ADDENDUM NO. 1

**TO SPECIFICATIONS AND PLANS FOR THE
CITY OF TRAVERSE CITY**

Grand Traverse Commons Water System Improvement Project

ISSUED: April 10, 2025

PROPOSED WATER MAIN DEFLECTION AT UNDERGROUND UTILITY TUNNELS
N.T.S.

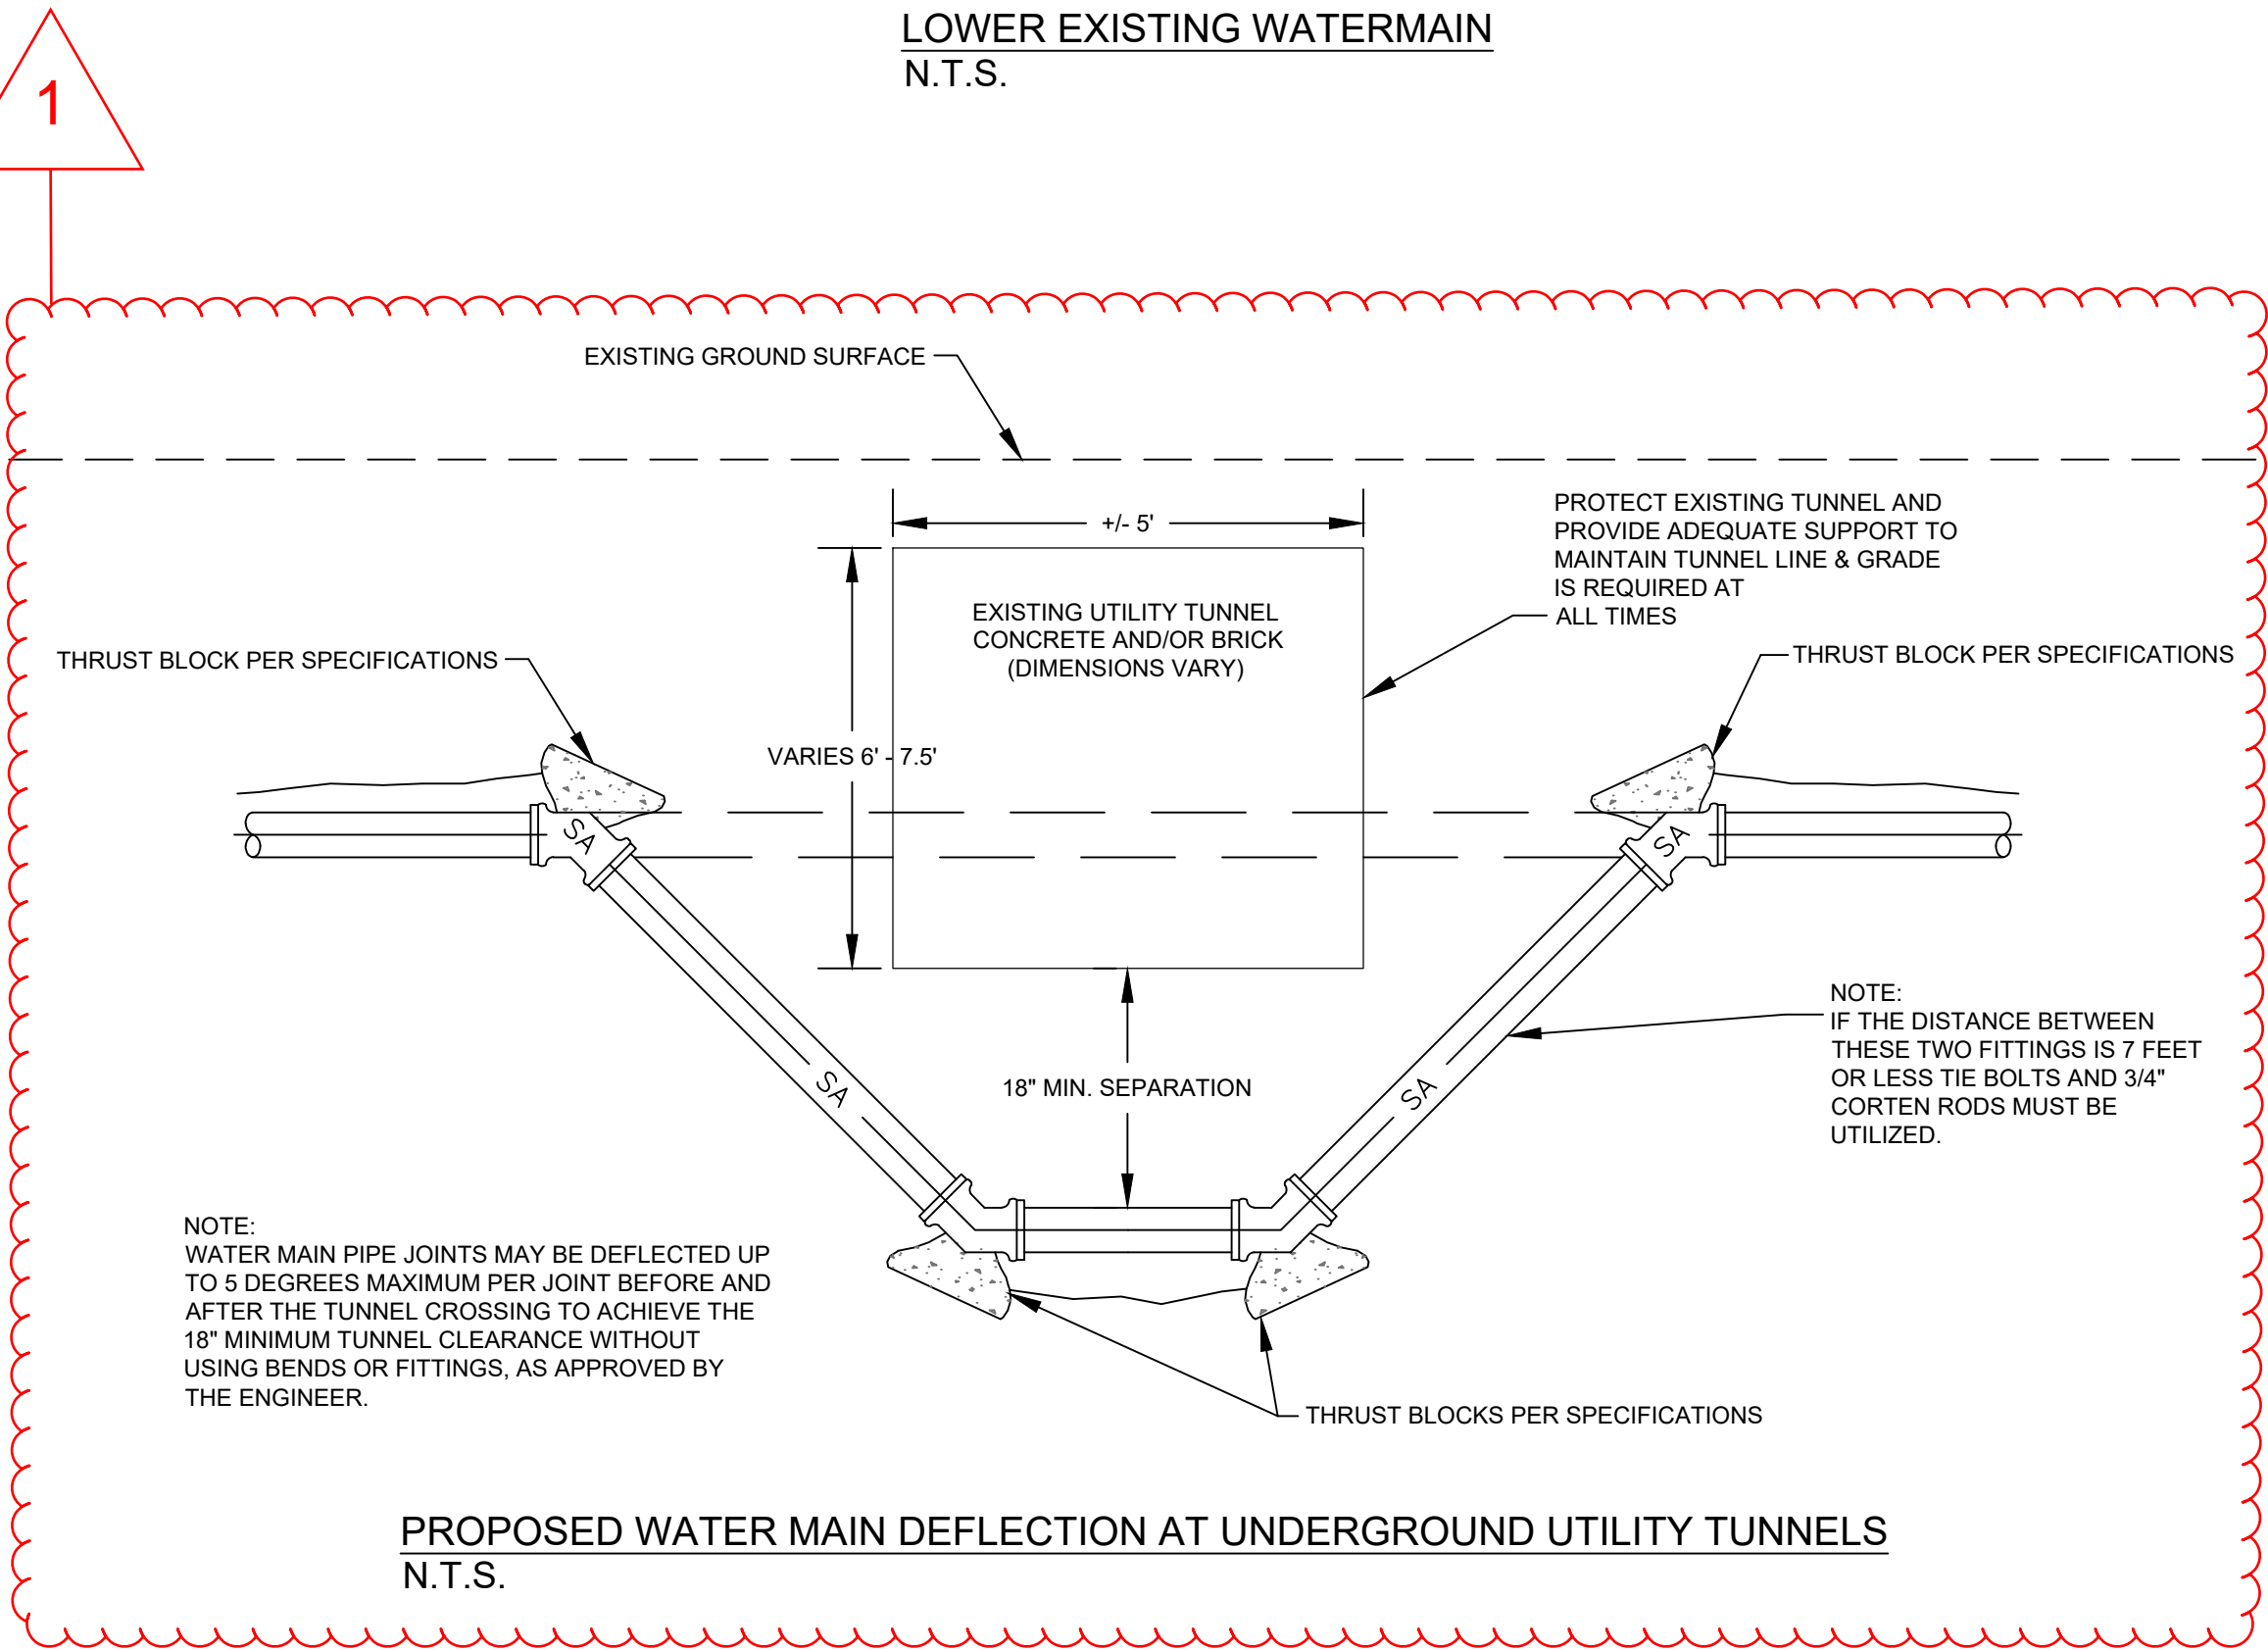
Answer 4: Yes, there are tunnels present that will most likely be encountered during construction. These tunnels have a top width of +/- 5' and a bottom depth ranging from

6' deep to 7.5' deep. A pay item has been added to the contract via this addendum. The pay item is "Underground Utility Tunnel, Conflict" – Ea. This item will cover additional costs incurred by the Contractor for providing the required 18" of separation between the water main and the bottom of the tunnel, as well as supporting the tunnel. The cost of installing the water main will be paid for separately. A detail has been added to sheet 4, and a specification and pay item added to the Bid Item Description section of the specifications.
